Immingham Green Energy Terminal

9.3 Applicant's Responses to the Examining Authority's First
Written Questions

(Responses to "Q1.8. Flood Risk and Coastal Change")

Document Reference: TR030008/EXAM/9.3

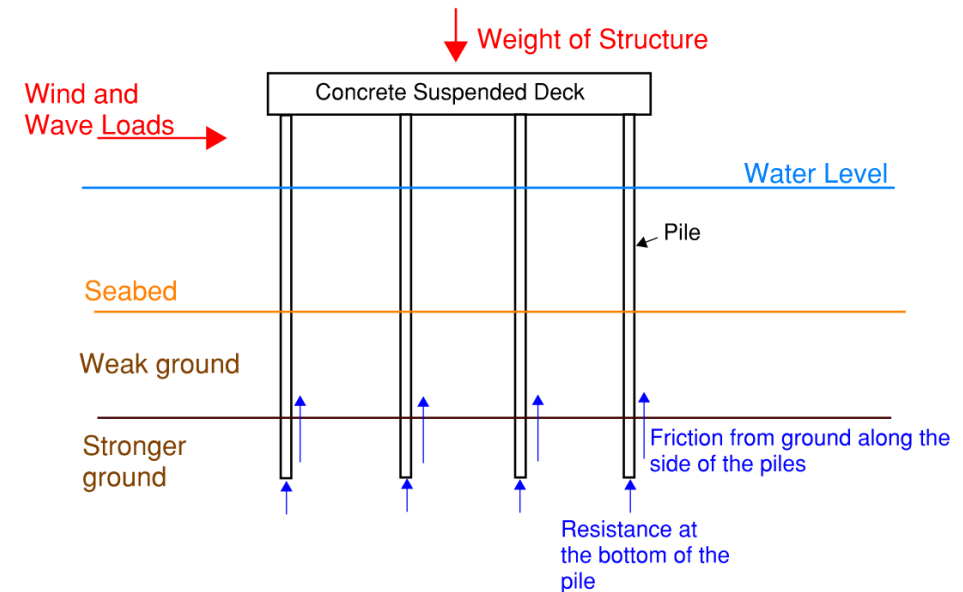
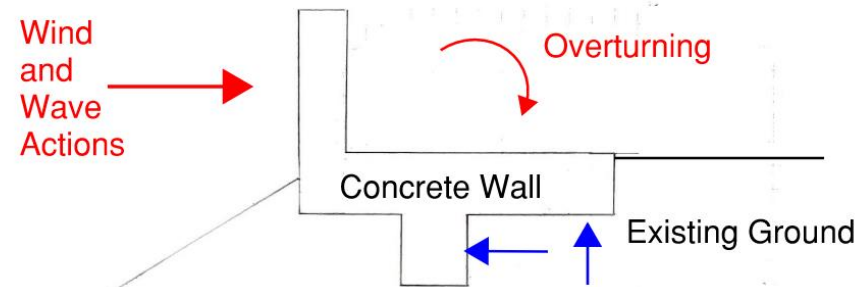
<p>Q1.8.3.2</p>	
<p>Question</p>	<p>Response</p>
<p>Wind and Wave Effects on Tall Structures</p> <p>The Scoping Opinion [APP-168, ID 3.14.2 and Page 3] refers to guidance from the EA, which advises on wind. The ES [APP-061, Paragraph 19.7.7] states the design of tall structures and jetties will be reviewed to ensure stability in stronger wind and wave actions. Provide illustrative information on the types of design solutions that might be available in this regard.</p>	<p>Types of design solutions that are available for implementation in the sea to ensure stability in strong wind and wave actions are:</p> <ul style="list-style-type: none"> • Piled suspended decks – as per the Application design <ul style="list-style-type: none"> ○ Design may have vertical or raking piles ○ Design may have 'jacket' substructures with bracing between piles • Concrete Gravity structures <p>Wind and wave actions act on the vessels, which transfer loads to the structure via contact with fenders and mooring points and act directly on the structures themselves.</p>

The jetty is also designed for direct wind and wave loads in the design in line with the European and British Standards for structural design of maritime structures. Wave loads and associated water levels have been derived for present day and future events in line with EA Flood Risk Assessment – Climate change guidance (Environment Agency, 2022).

These are global destabilising forces which are counteracted by the weight of the structures and their embedment in the ground, e.g. in the case of piles.

An illustration of load transfer to piles and supporting resistance is given below:

- The Approach Jetty's ramp, which is mainly subject to wind load, and which may be a suspended deck on piles, as per the Application design, or a gravity structure, rubble mound or steel sheet piled structure.
- The flood defence wall, which would be primarily subject to wave load, and which is proposed to be a gravity structure with a structural key into the top of the existing embankment but which

Gravity structures largely resist wave and wind destabilising forces by their weight and the ability of their footprint to transfer the loads to the underlying strata through sliding and bearing without causing failure. An illustrative example of the concrete flood defence wall which is acted upon by wind and wave loads, which cause sliding and overturning is below. The resistance is provided by the weight of the structure inducing sliding resistance and support from the existing ground.
